ORE - TRAFFIC: Jan 2026 Proposed TEM Updates Summary

Each proposed revision (row below) is bookmarked in the document

TEM 298-42 Draft
Updated Figure(s)

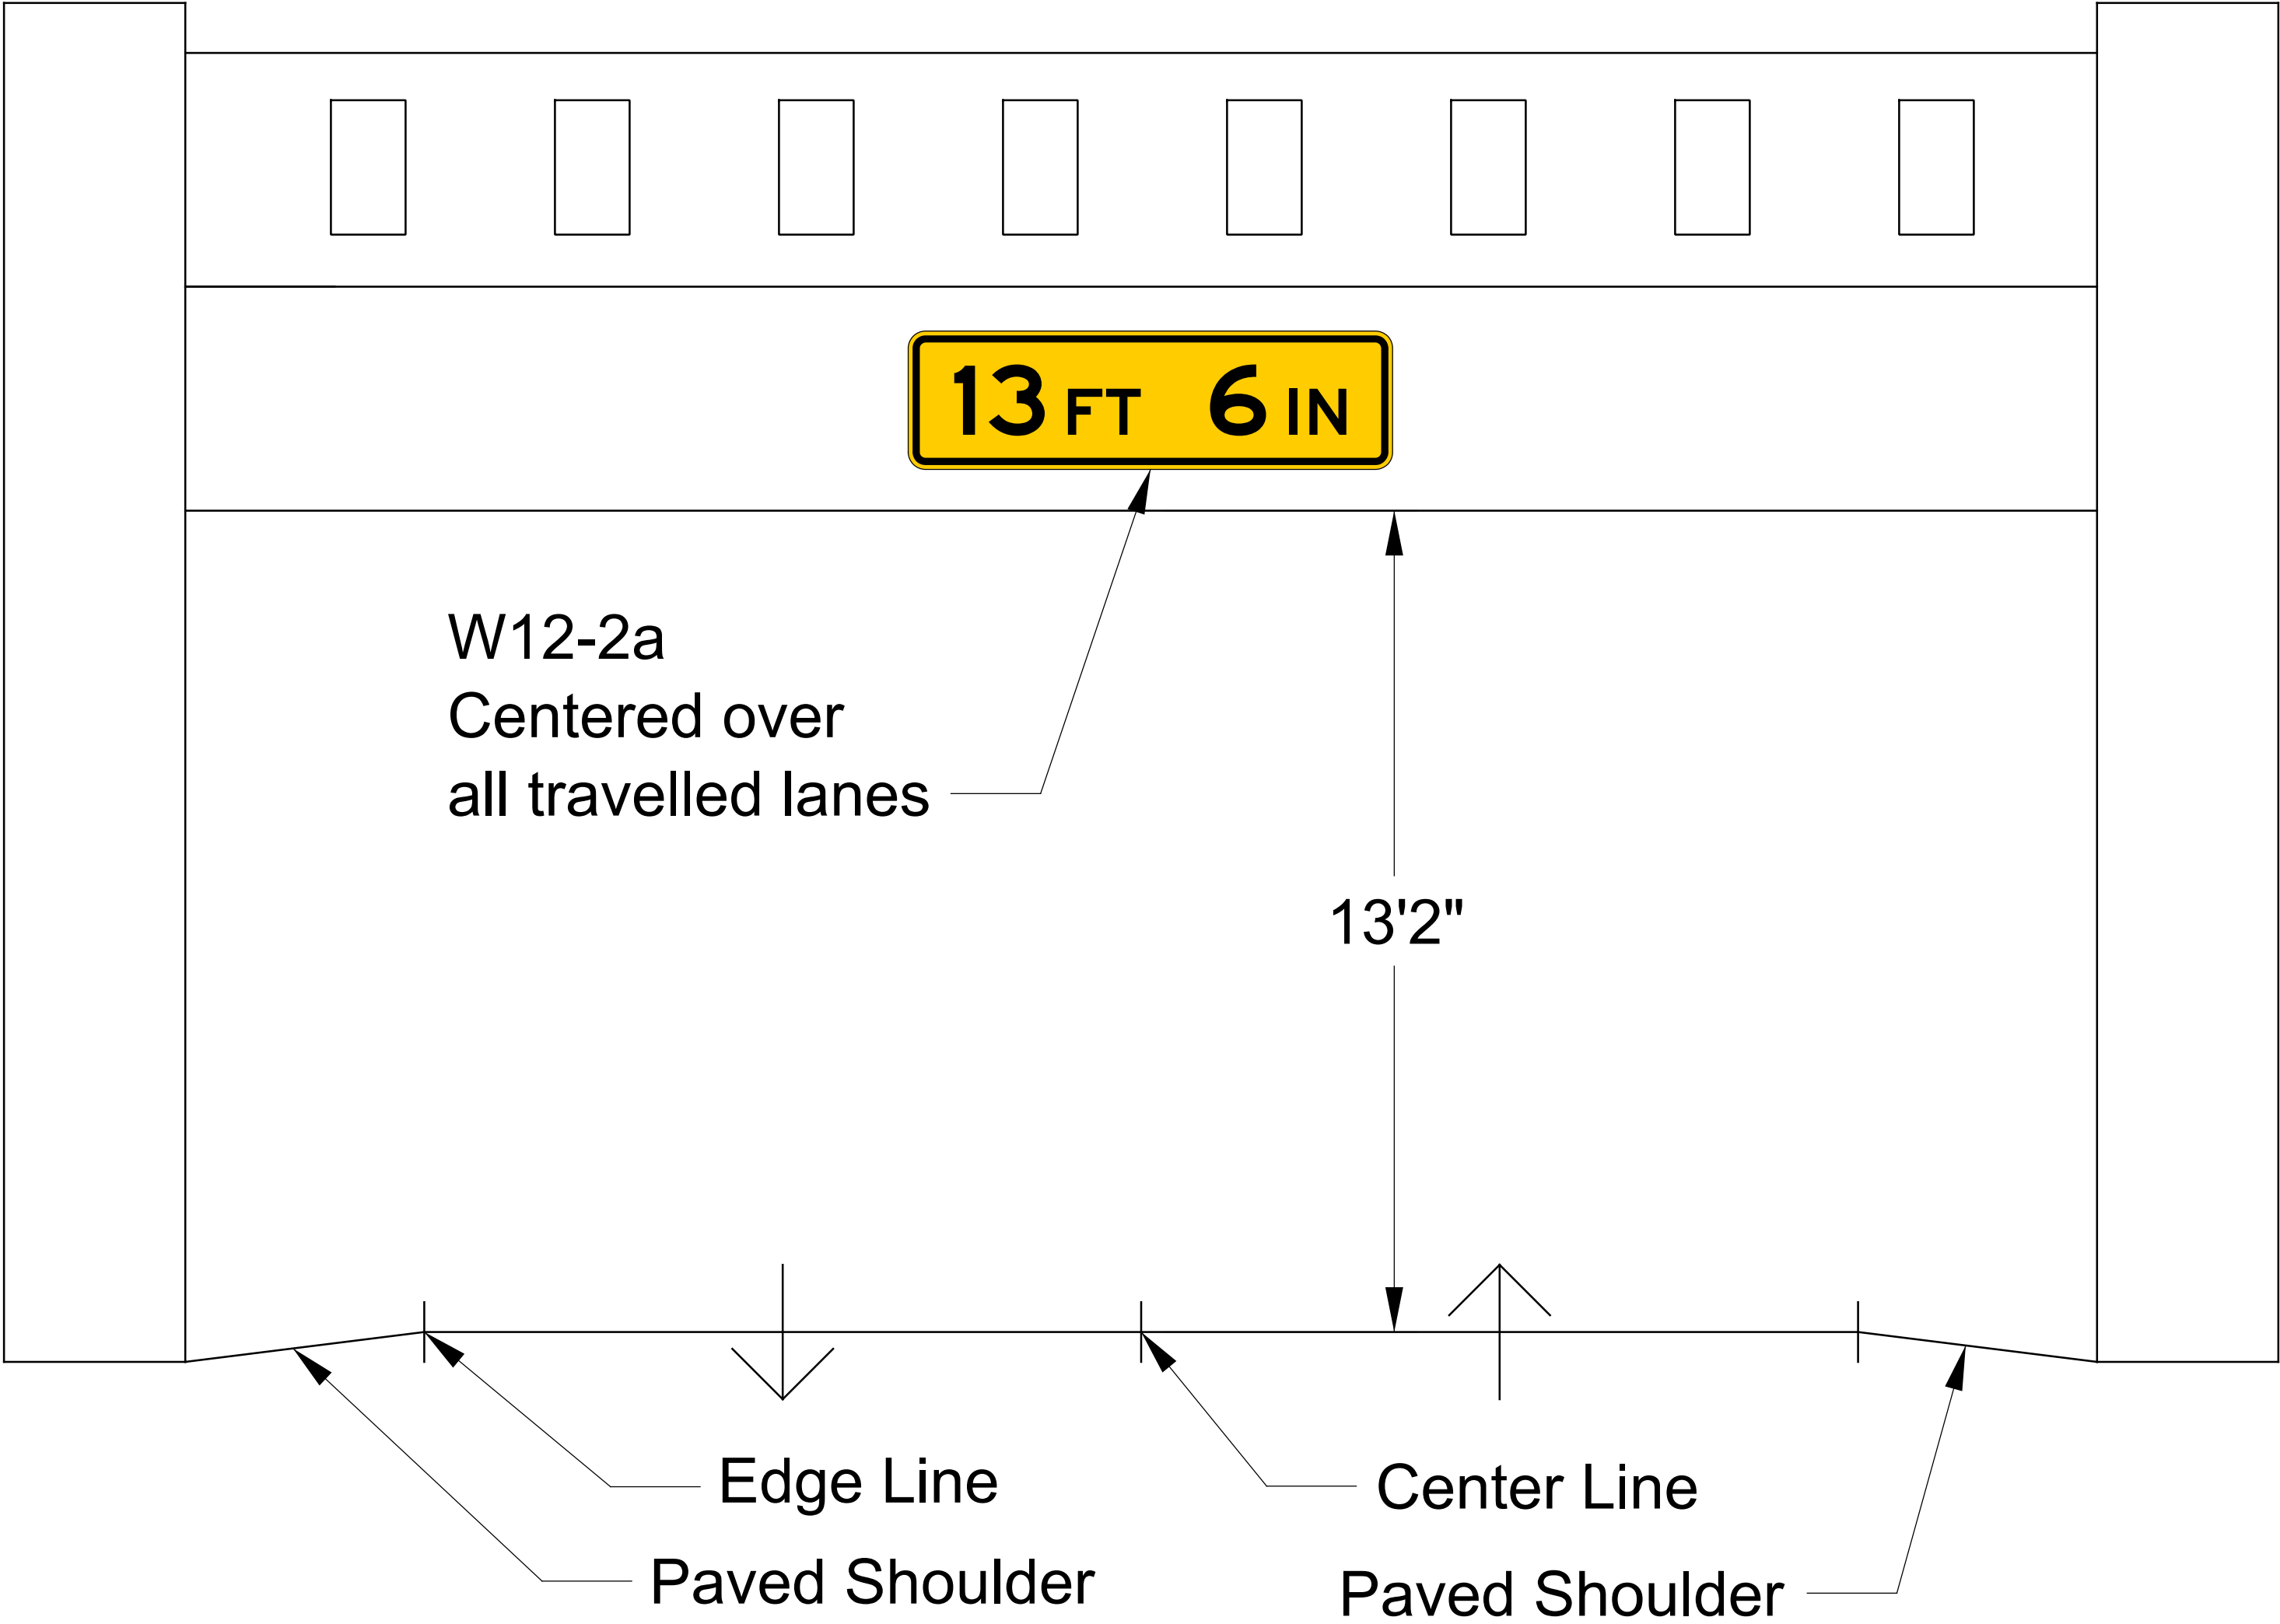
Added Additional bridge
posting layouts, and
Examples of signs being
posted on freeways and
conventional routes

NOTE:
All Low Clearance Signs displayed on bridge
use a 4" buffer from the actual low vertical
clearance (Actual Height - 4")
